Upper Trishuli-1 HEP (216MW)

| SUBJECT | Review Note RN-0314_Layout Drawing of Surge Tank | | |

## REVIEW NOTE

| Review Note No. | **RN-0314** | **Present Review Date** | **02.11.2022** |

RN-0314 ANNEX 1
02/11/2022

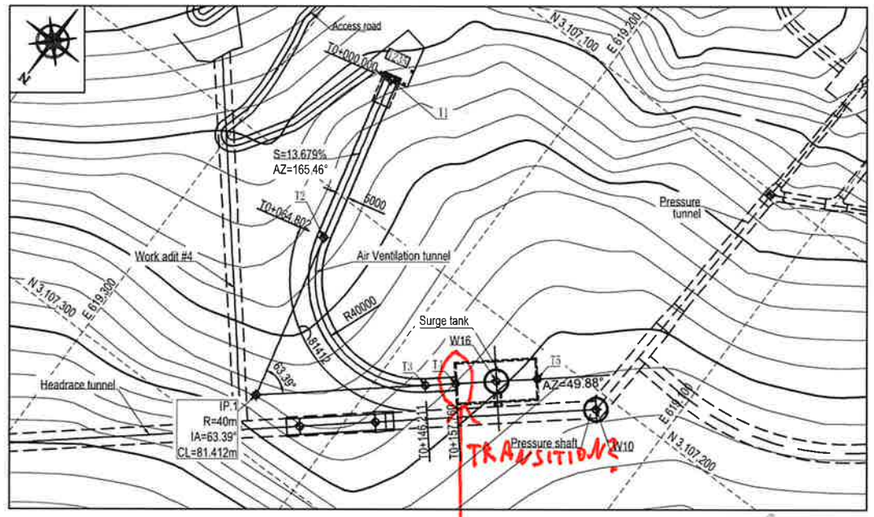
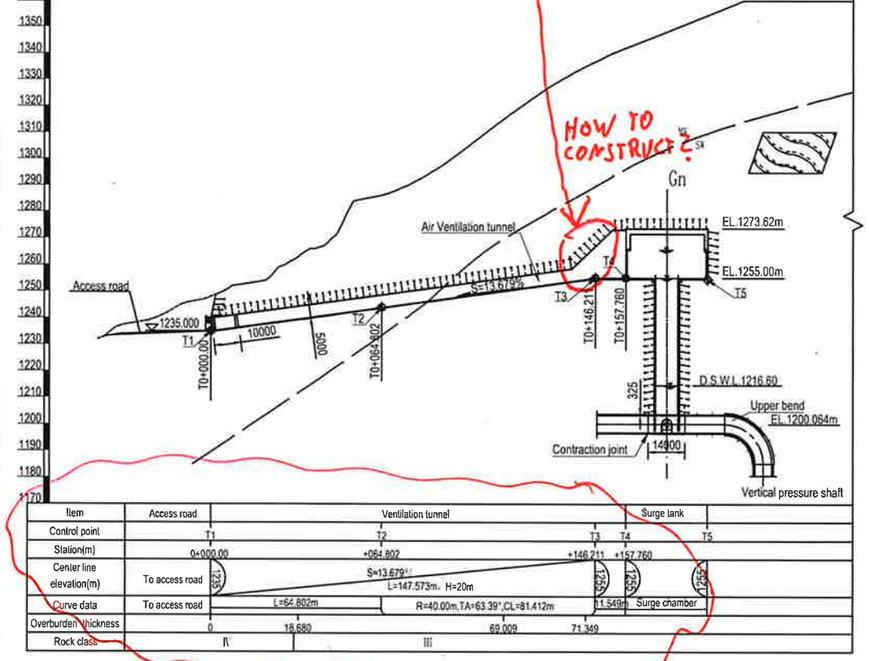
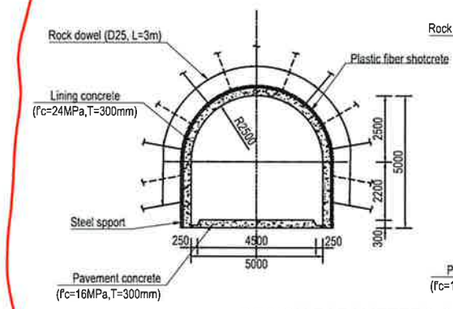
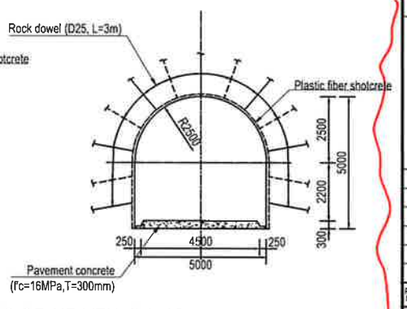
- WHY GEOLOGICAL INFORMATION IN GENERAL LAYOUT DRAWING 2 → SUBJECT TO SUPPORT DRAWINGS?
- AIR VENTILATION TUNNEL SEPARATE DRAWING

RN-0314, ANNEX 3
02/11/2022

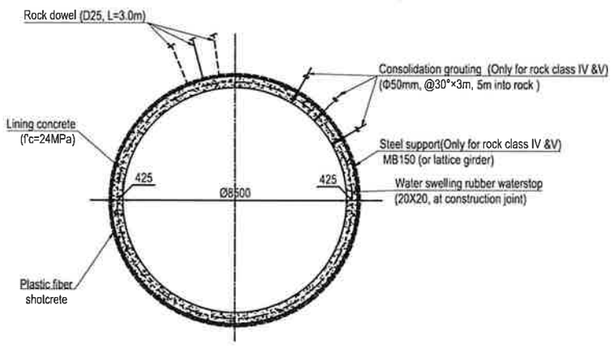
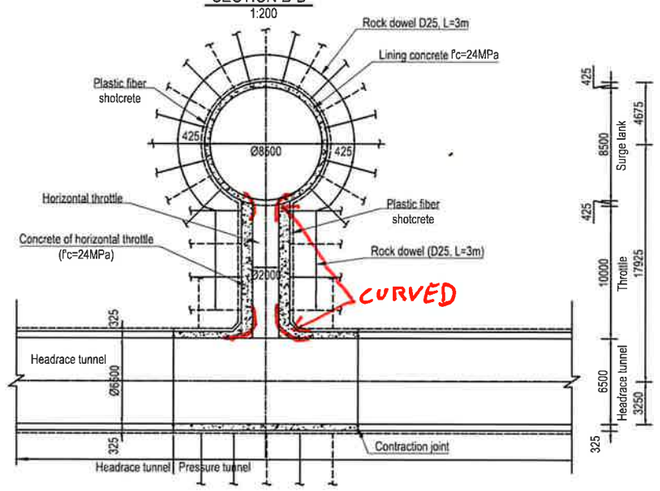
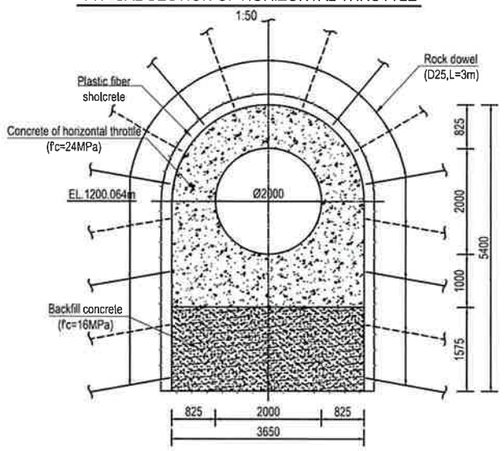
SIDEWALL CONCRETE f'c=24MPa AS INDICATED IN PROFILE AND SECTION A-A (SHEET 2/3)

SUBJECT TO ROCK SUPPORT CALCULATIONS / DRAWINGS
